**THE CITY OF ALEXANDER CITY, ALABAMA
MULTI AGENCY WASTEWATER SOLUTION – PROJECT “B”
HIGHWAY 128 SEWER FORCE MAIN
BID #24-03
(SRF PROJECT CS010329-05)**

ADDENDUM NO. 1

| Project No. | 09 | |

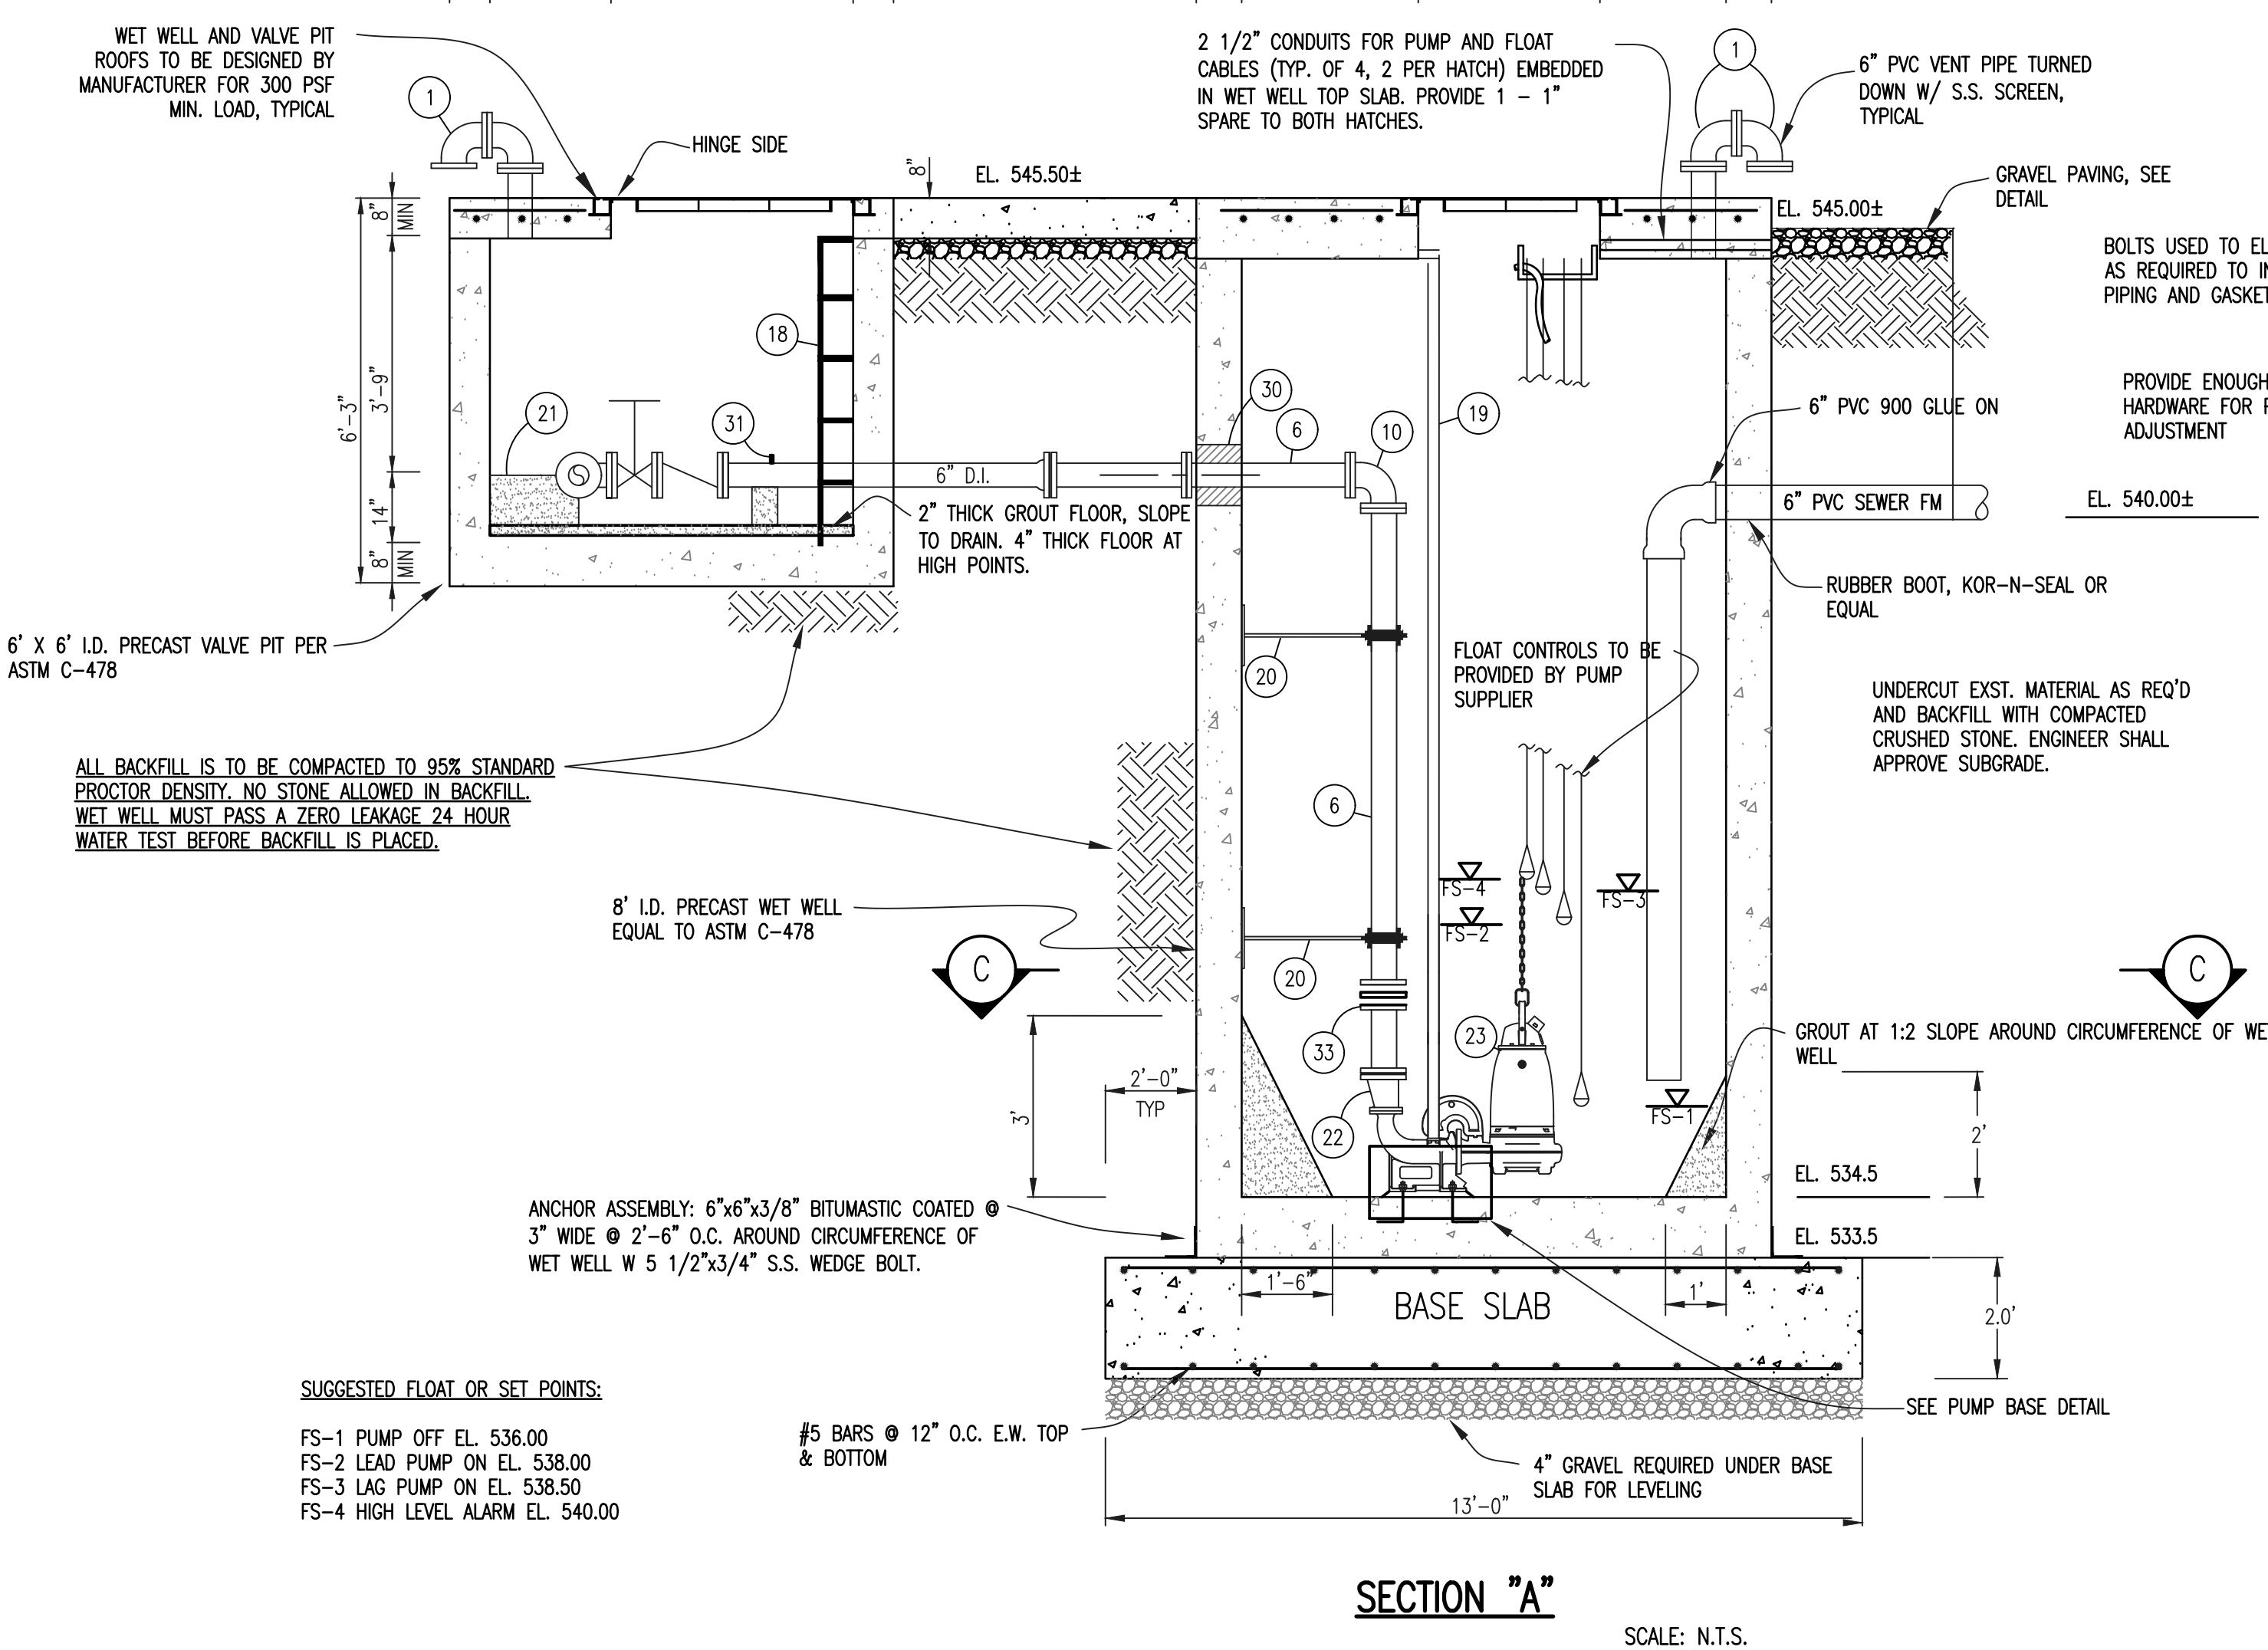
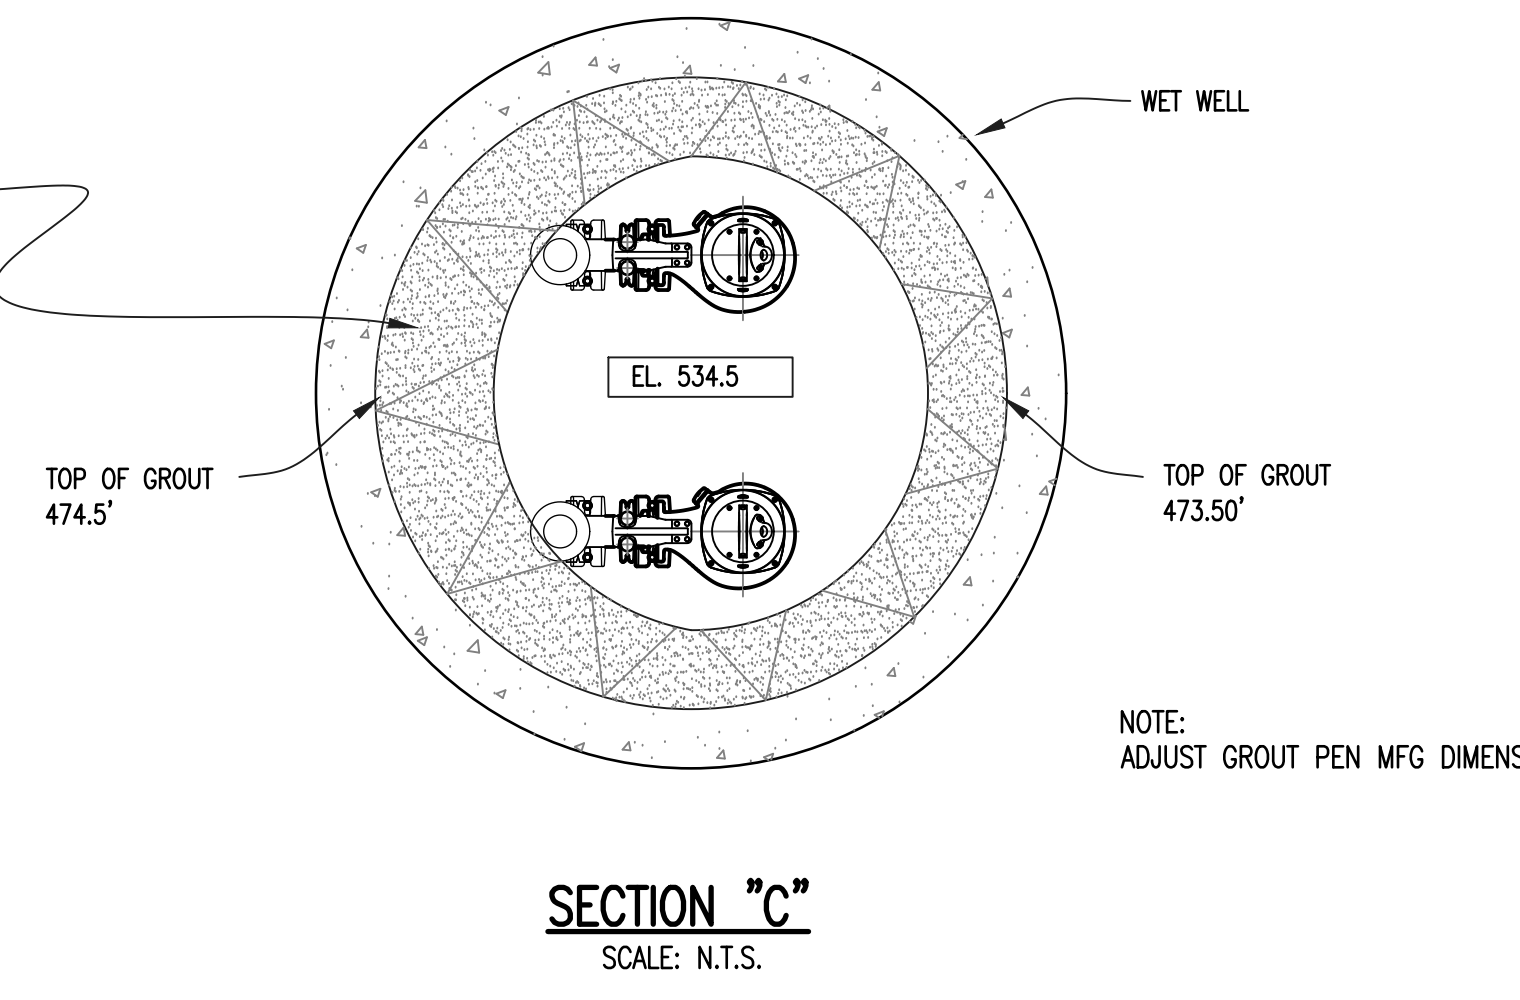
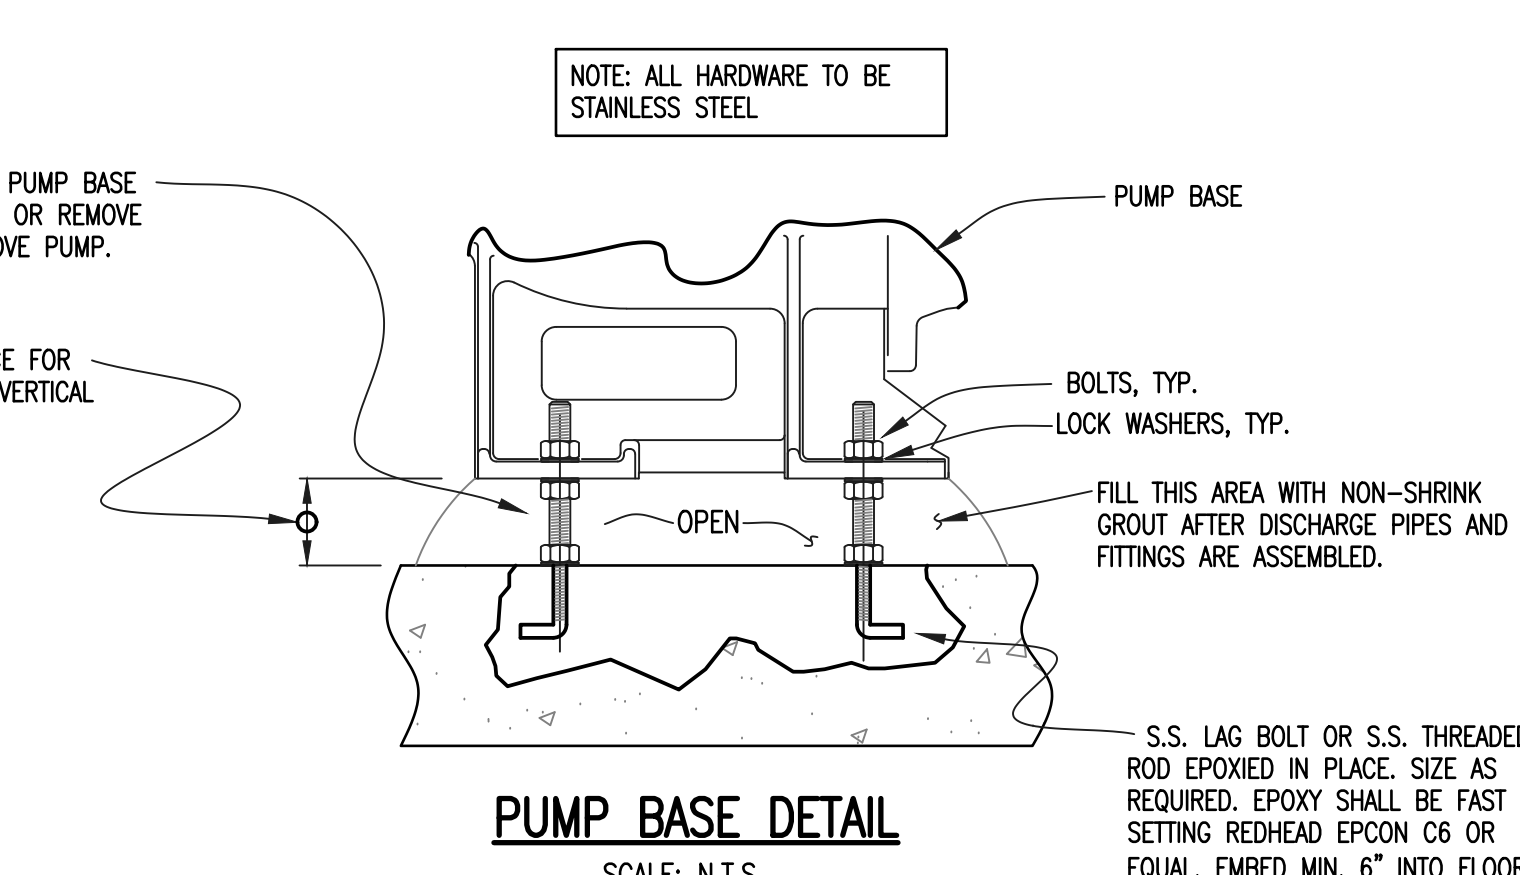
Sheet 9 Dimensions for Section “A” have been revised.

Sheet 9 Section “B” shown on the Plan has been included.
